AMENDMENTS TO THE DRAWINGS

REMARKS

This is intended as a full and complete response to the Final Office Action dated January 25, 2006, having a shortened statutory period for response set to expire on April 25, 2006. Please reconsider the claims pending in the application for reasons discussed below.

Fig. 1

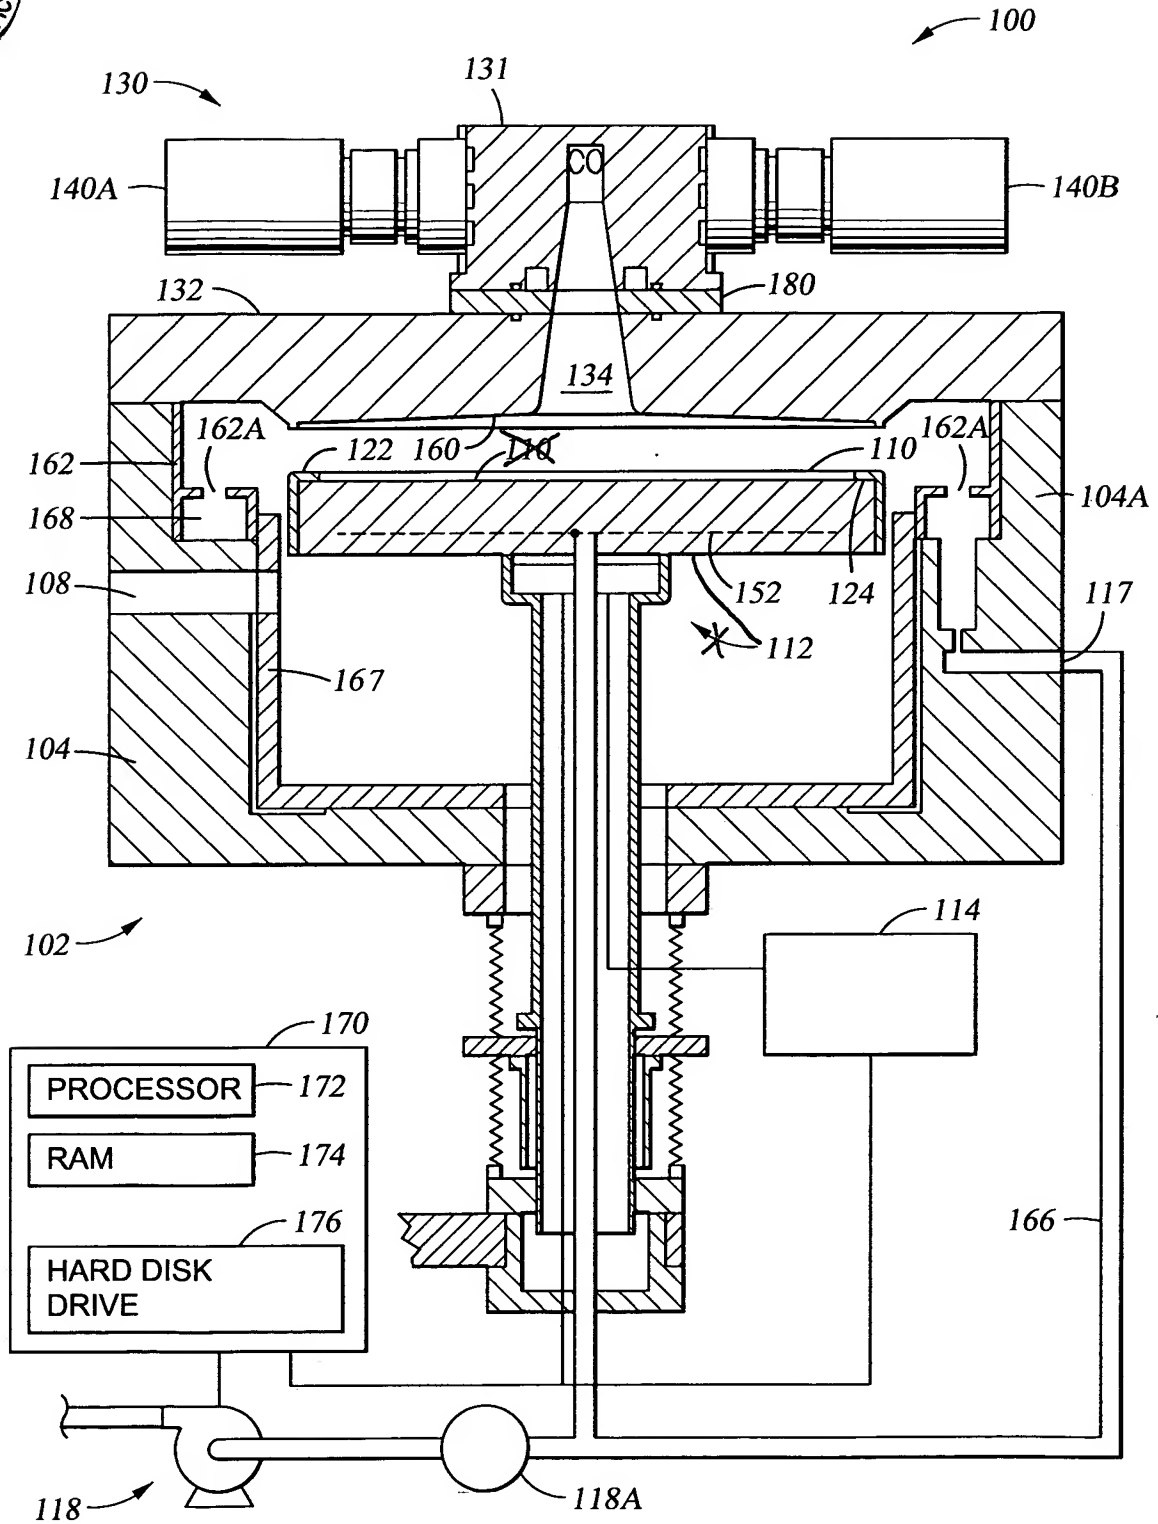
Replacement Sheet 1, Figure 1 – An excess element numeral 110 was removed, element numeral 112 was redirected, and the hatching of element 180 was amended within the figure;

Fig. 2

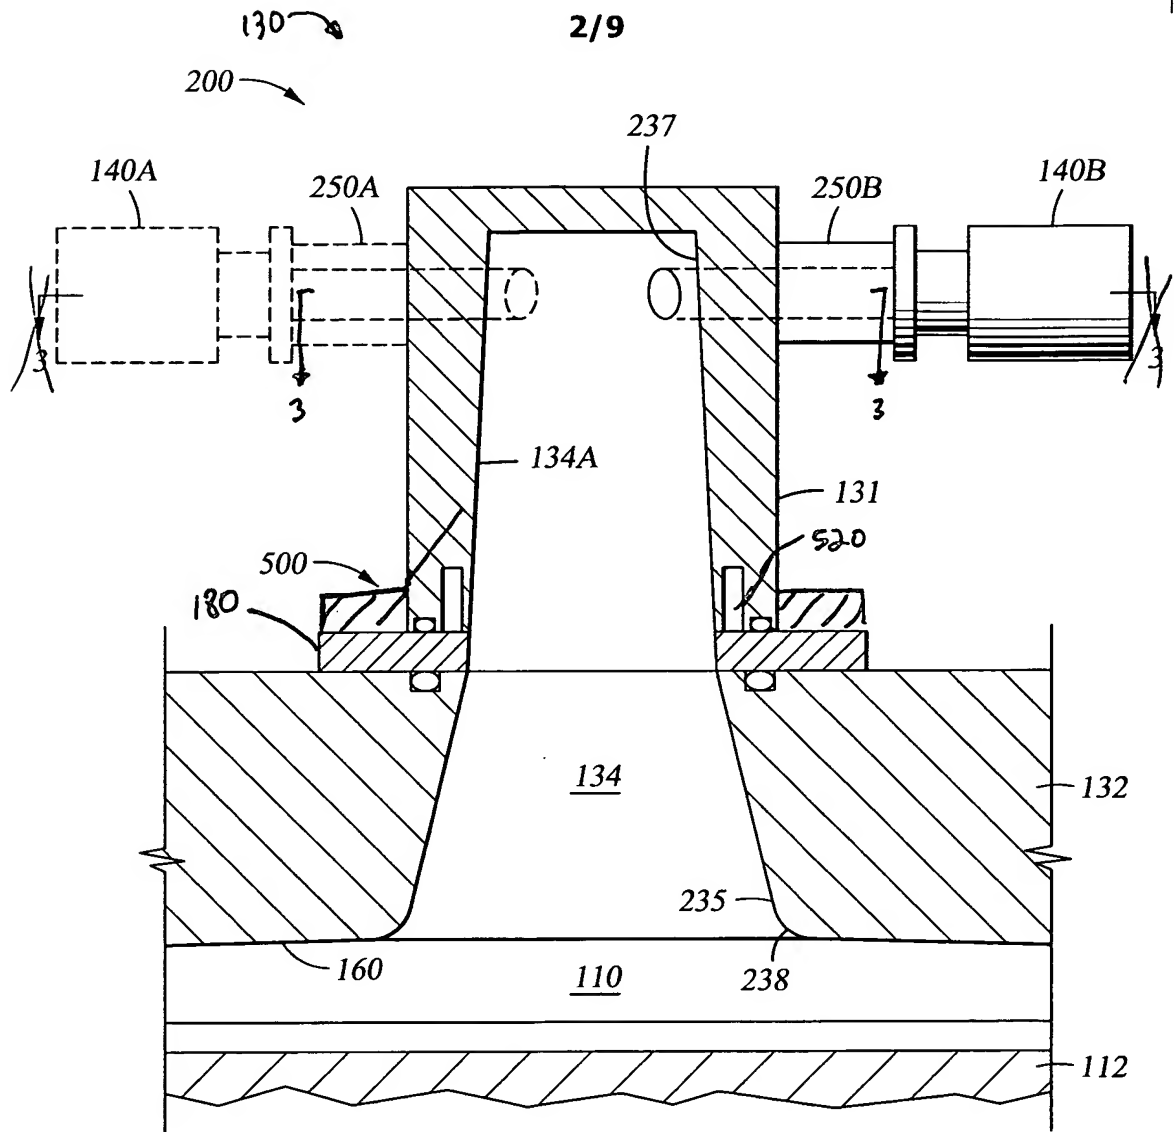
Replacement Sheet 2, Figure 2 – Element numerals 130, 180, and 520 were added, the view arrows of Figure 3 was re-positioned, the hatching of elements 131, 132, and 180 was amended, and element 131 was amended within the figure;

Fig. 3

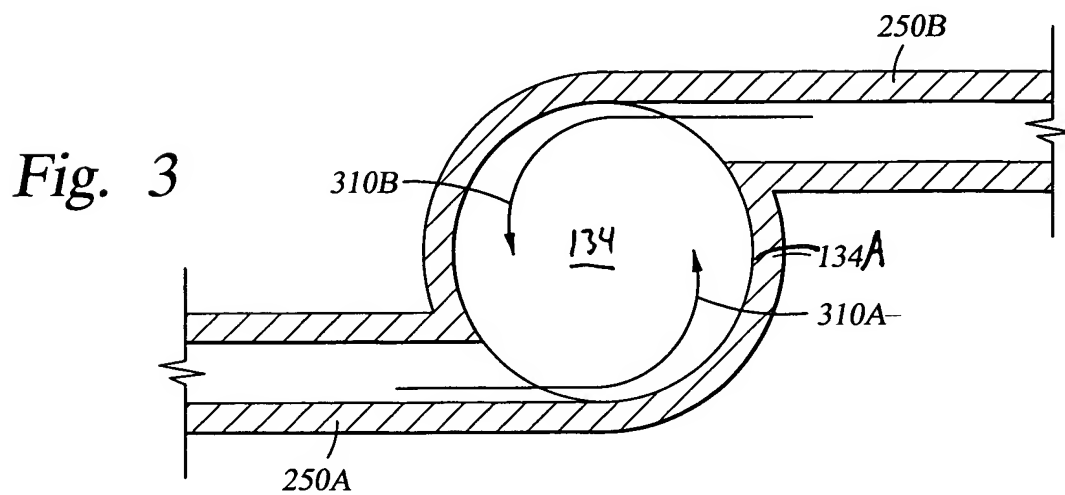
Replacement Sheet 2, Figure 3 – Element numeral 134 was added and element numeral 134A was amended within the figure;

Fig. 5A

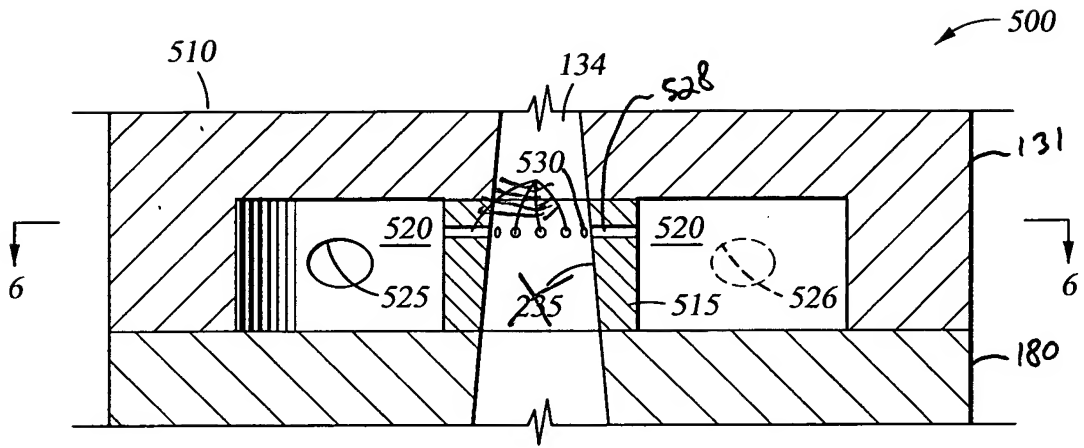
Replacement Sheet 4, Figure 5A – Element numerals 131, 180, and 528 were added, element numeral 235 was removed, the hatching of element 180 was amended, and element numeral 530 was redirected within the figure;

Fig. 5B

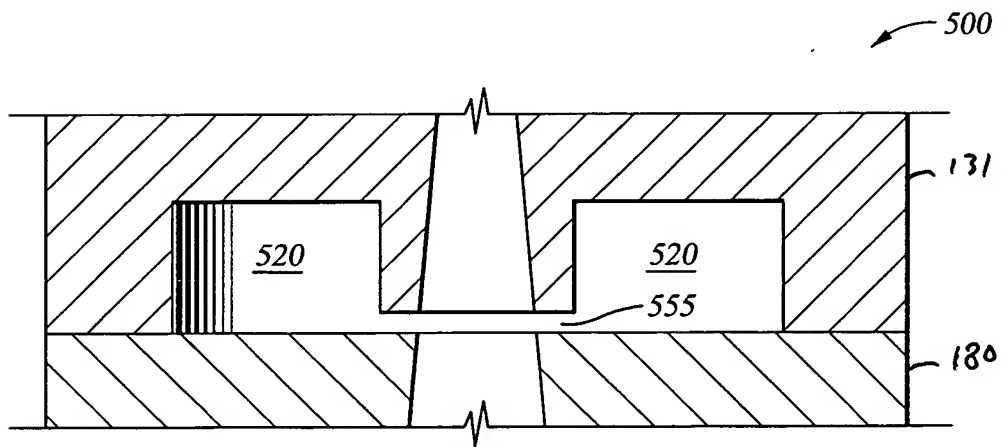
Replacement Sheet 4, Figure 5B – Element numerals 131 and 180 were added and the hatching of element 180 was amended within the figure;

Fig. 6

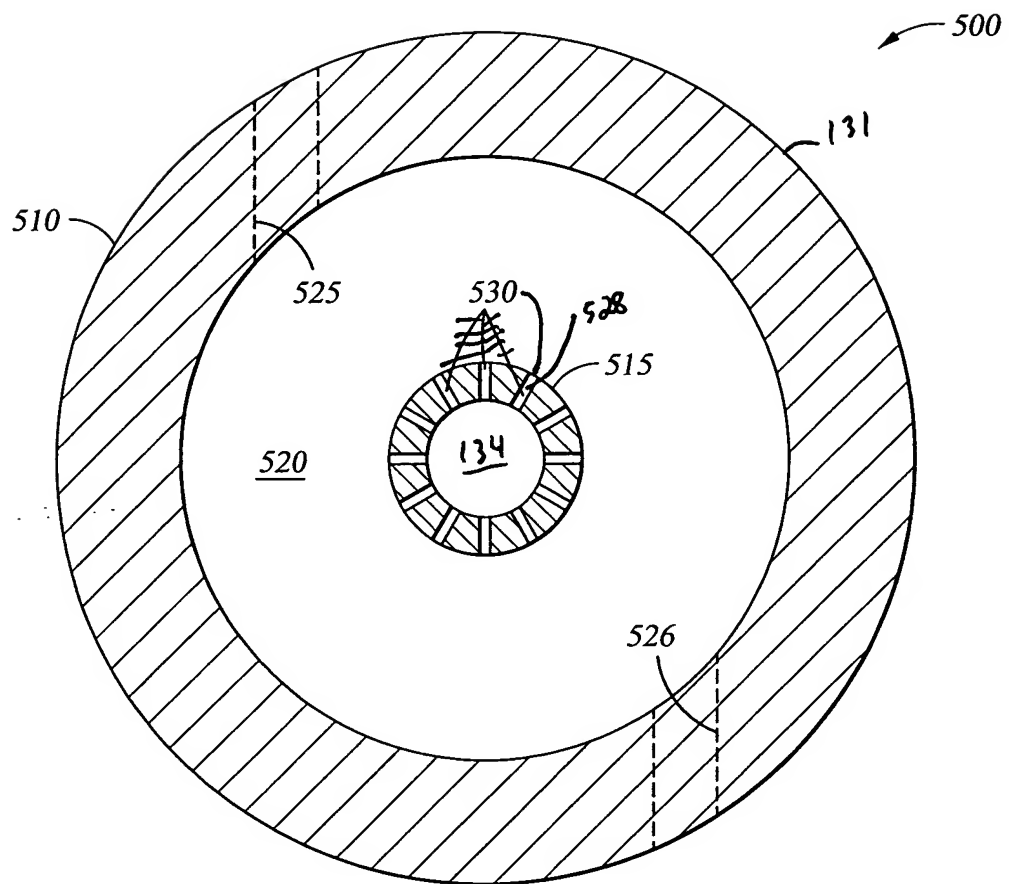
Replacement Sheet 5, Figure 6 – Element numerals 131, 134, and 528 were added and element numeral 530 was redirected within the figure;

Fig. 6A

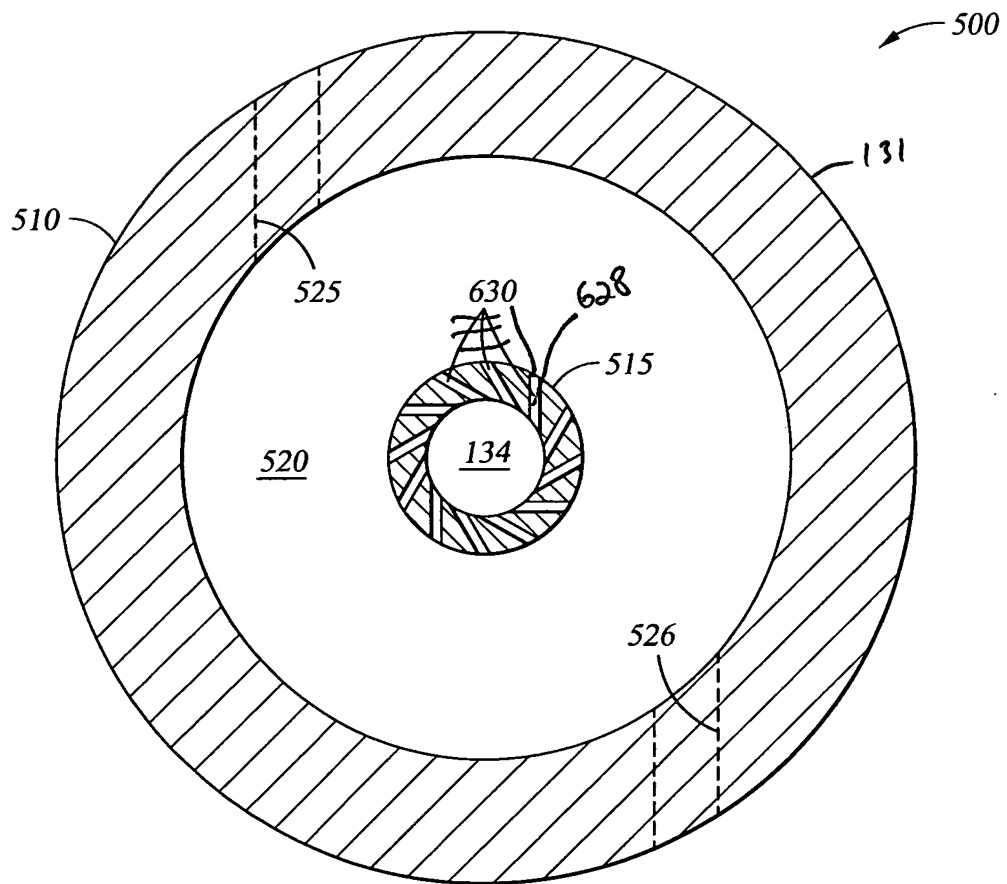
Replacement Sheet 6, Figure 6A – Element numerals 131 and 628 were added and element numeral 630 was redirected within the figure;

Fig. 7A

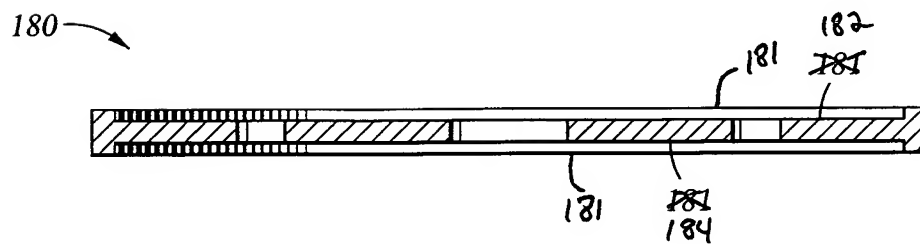
Replacement Sheet 7, Figure 7A – Element numerals 182 and 184 were added and element numeral 181 was redirected within the figure;

Fig. 8A

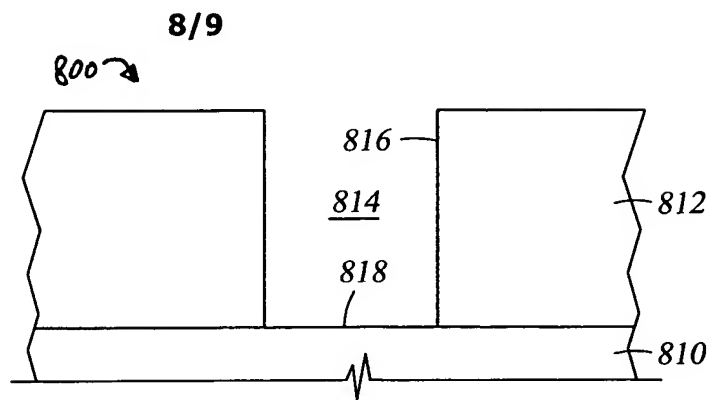
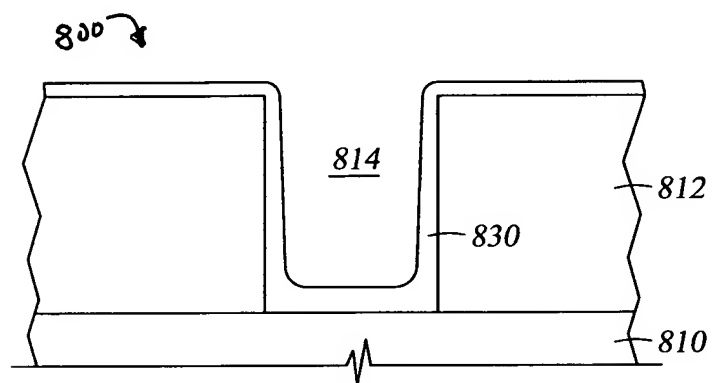
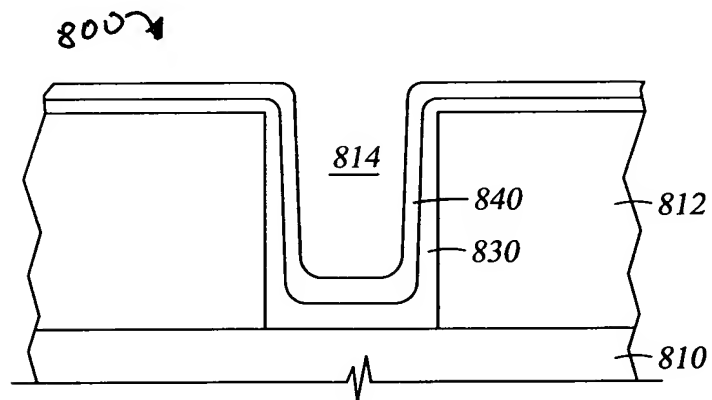
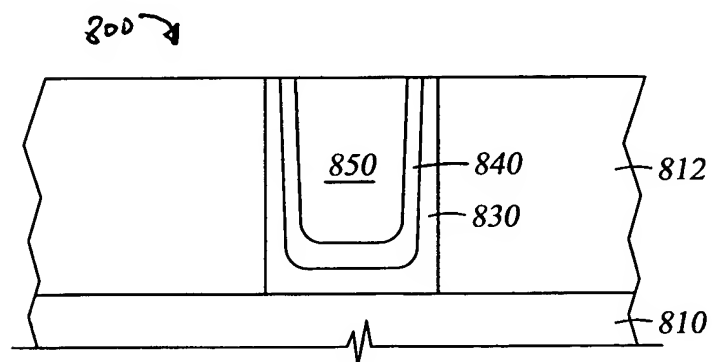
Replacement Sheet 8, Figure 8A-8D – Element numeral 800 was added within the figure; and

Fig. 9

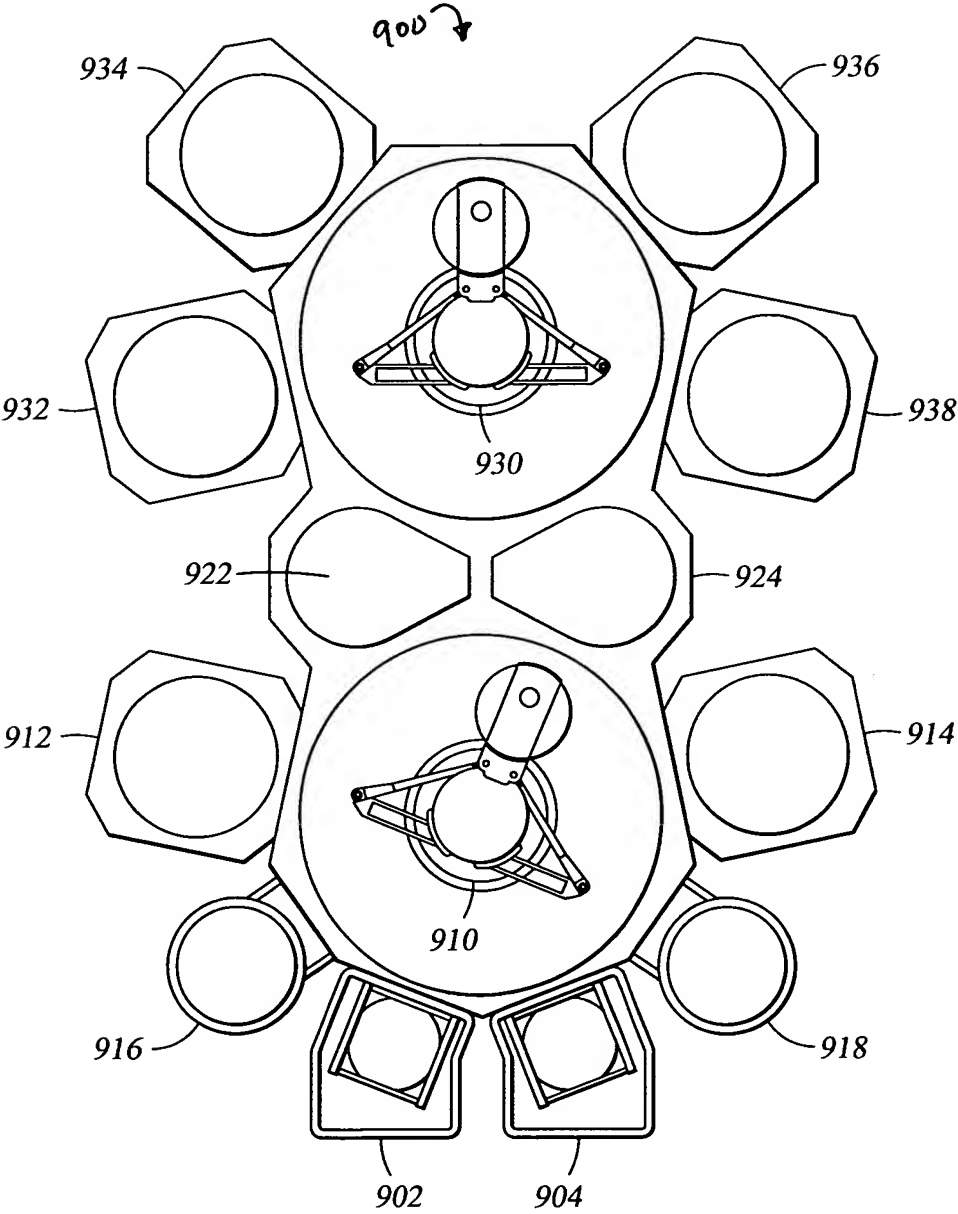
Replacement Sheet 9, Figure 9 – Element numeral 900 was added within the figure.
